REVIEW OF ECONOMIC ASSESSMENTS

AER BRIEFING

8 June 2017

EC.14077 MANNUM TRANSFORMER 1 AND 2 REPLACEMENT

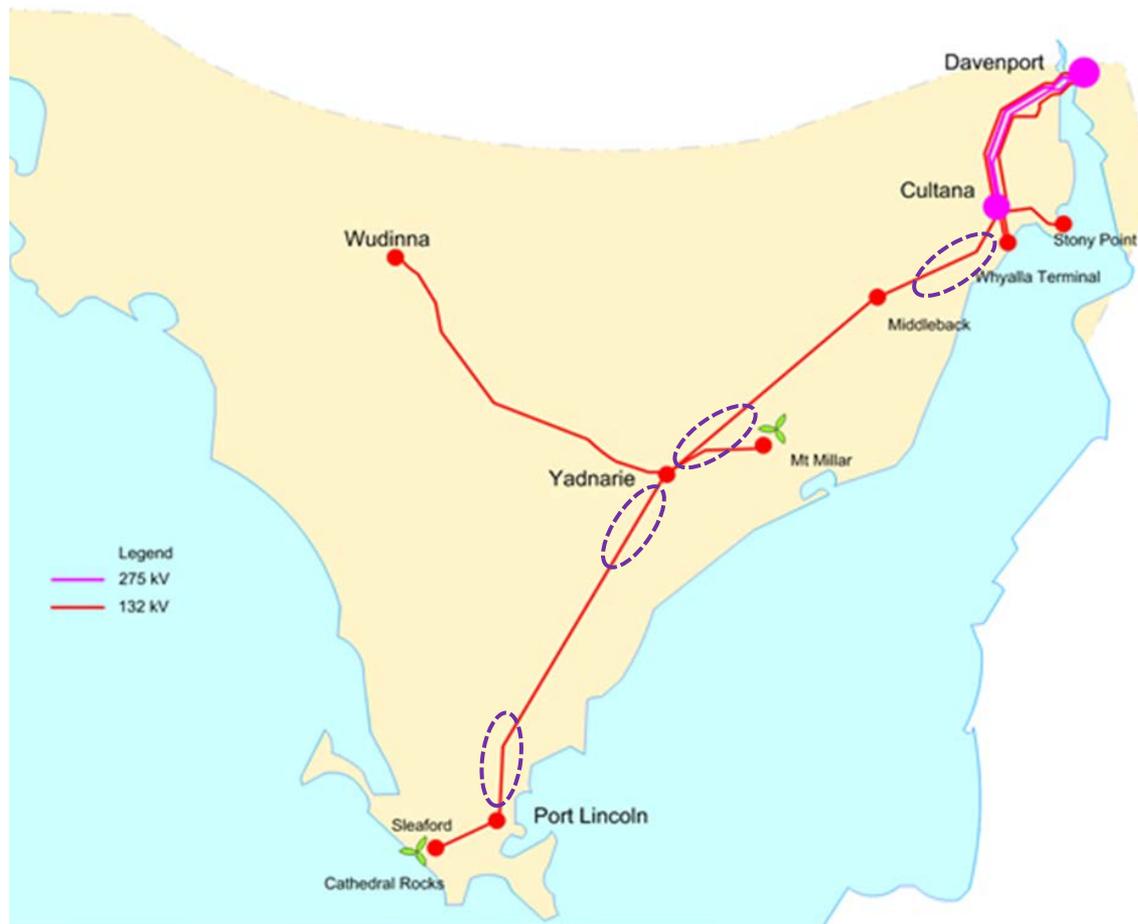
- ElectraNet has selected its standard transformer sizes to enable efficiencies in procurement, spares, ability to be re-deployed, engineering design etc. ElectraNet's standard 132/33kV transformer size that can accommodate a forecast peak load of 14.8 MVA is 25 MVA.
- ElectraNet is required to maintain N-1 transformer capability at the Mannum connection point
- A smaller transformer size (e.g. 20MVA) would offer minimal capital cost savings (estimated at ~4%) which would be expected to be eroded by the other issues inherent in a non-standard size.
- As such ElectraNet does not consider that a smaller size (2 X 20 MVA) is a prudent or efficient investment solution
